CITY OF ALBUQUERQUE

RE: Horizon Auto Glass & Tint 8310 San Pedro Dr. NE Permanent C.O. – Not Accepted Temporary C.O. - Accepted Engineer's Certification Date: 07/25/22 Engineer's Stamp Date: 02/22/21

Hydrology File: C18D107

Hydrology Report MILLER ENGINEERING CONSULTANTS Engineers • Planners

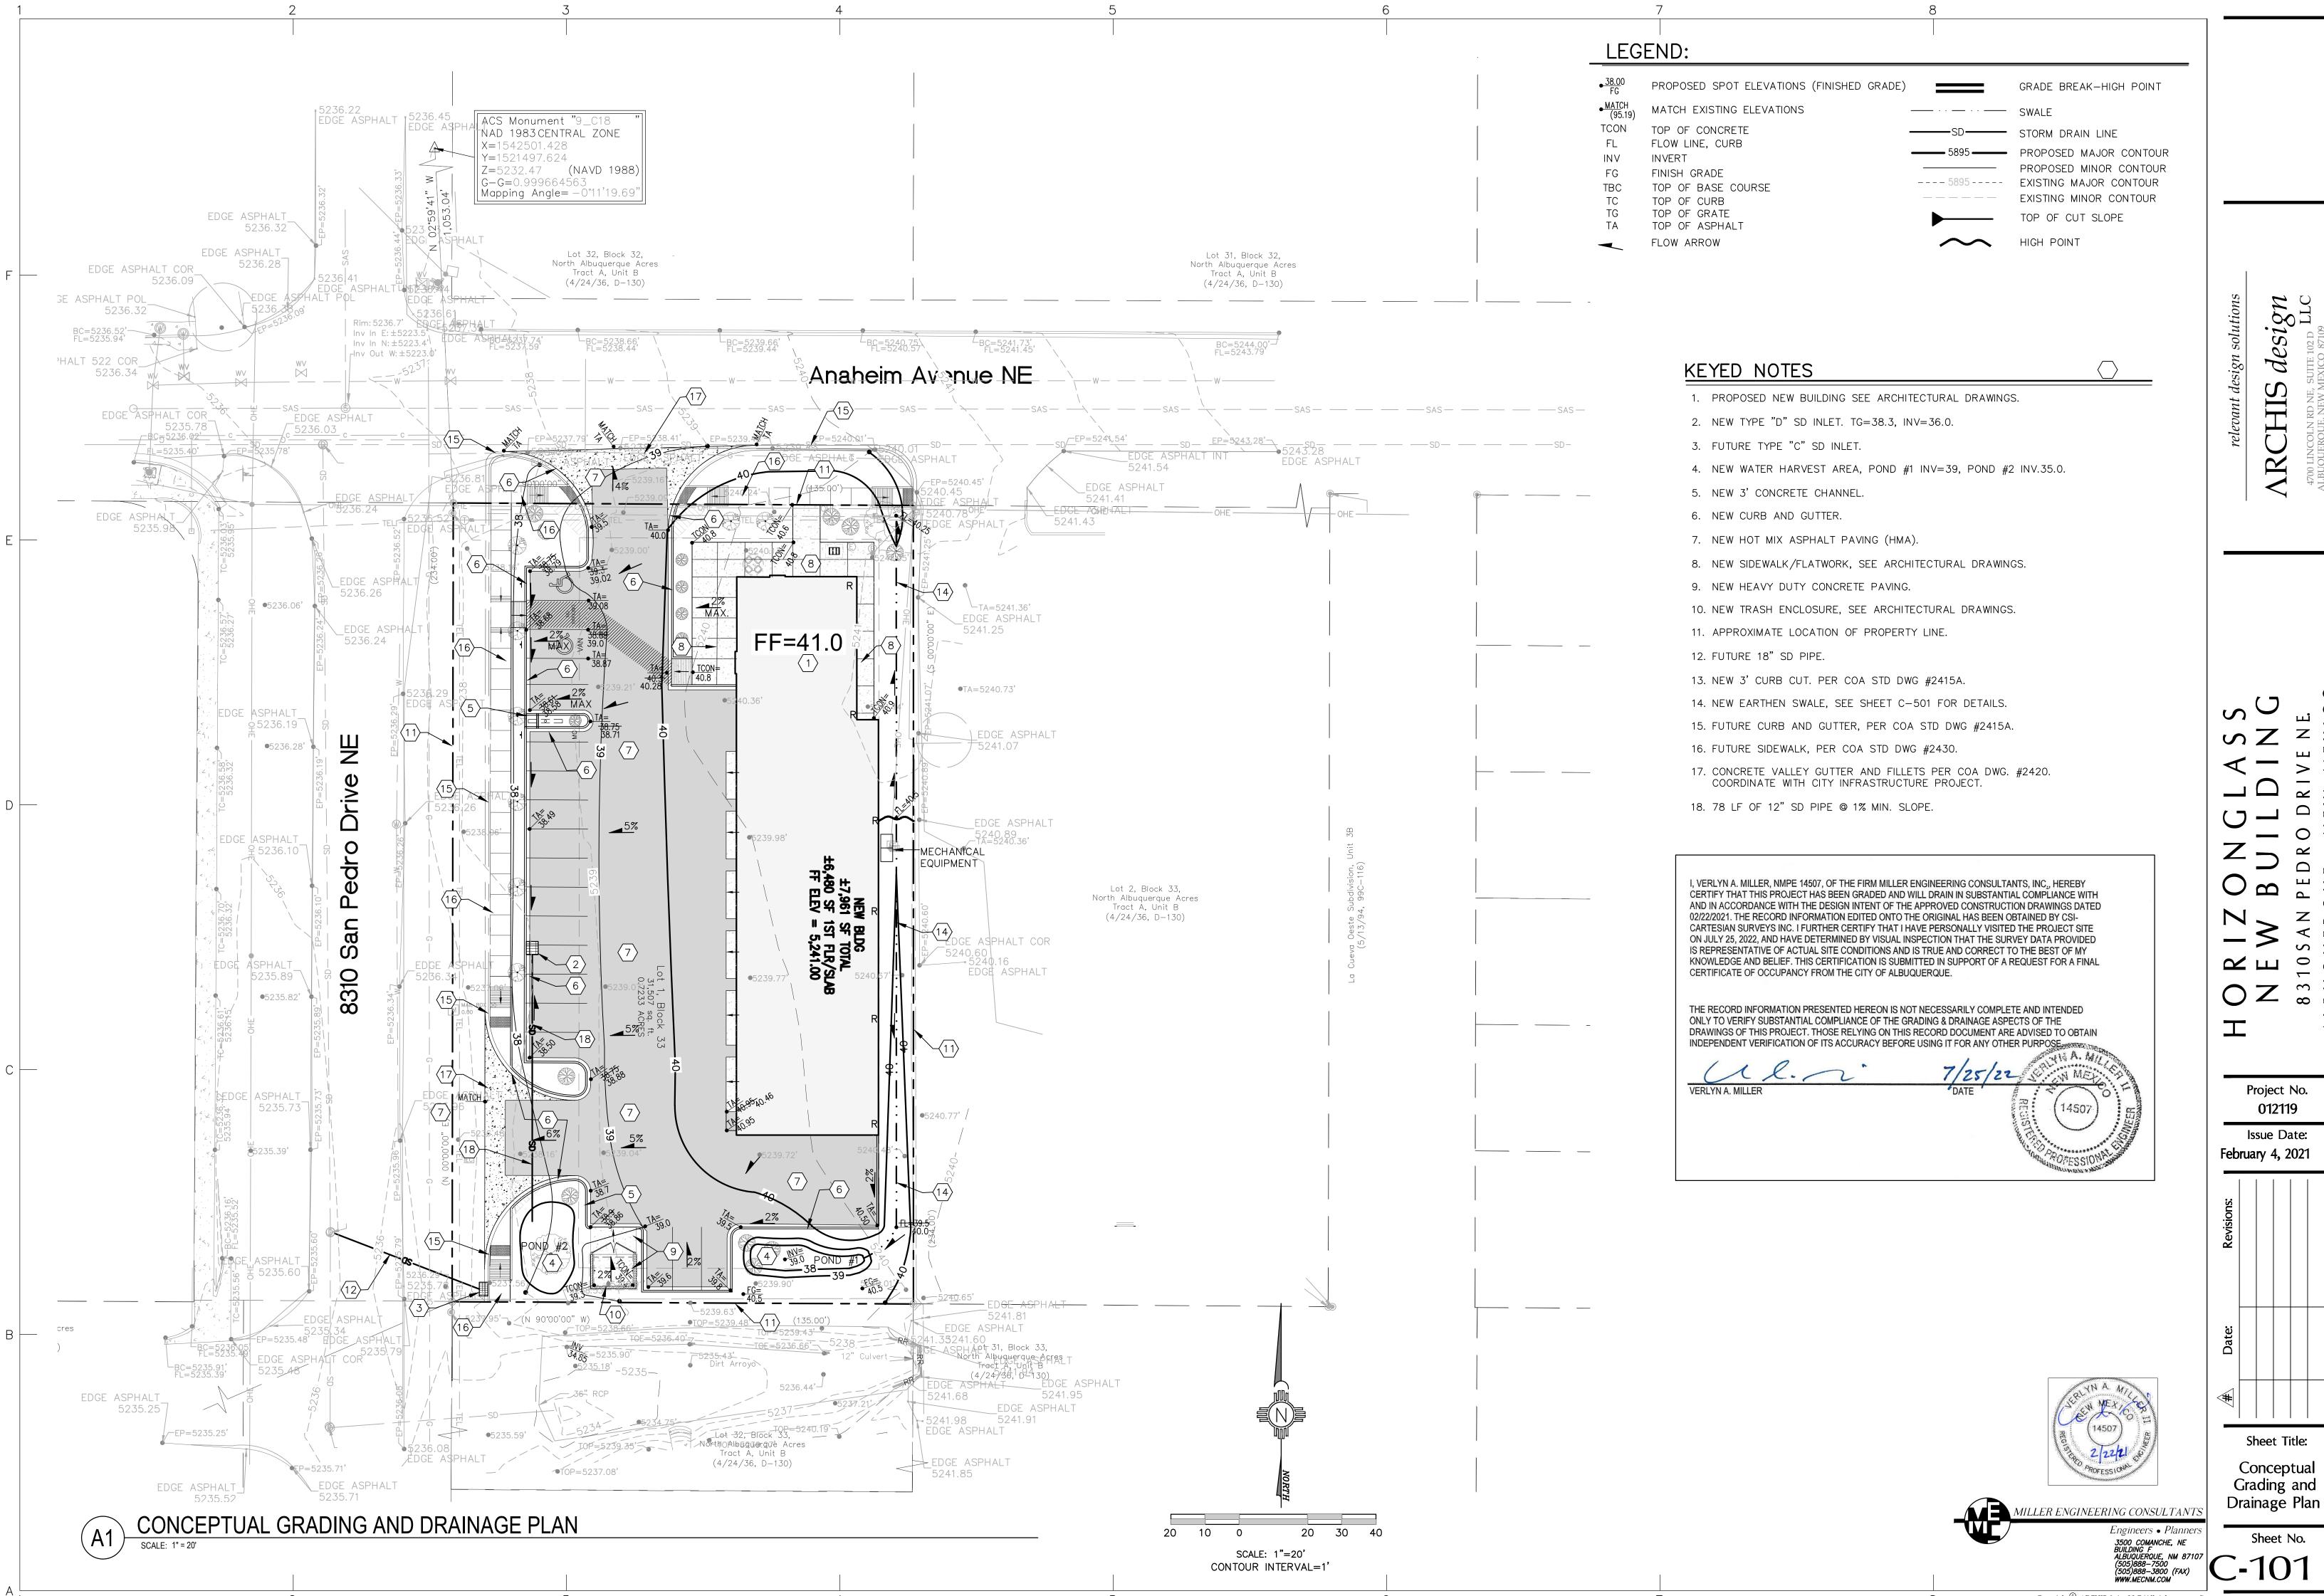
1. Please provide the as-built volumes of Pond 1 & Pond 2. Then please red line out as shown below and add the text showing the as-built volumes provided.
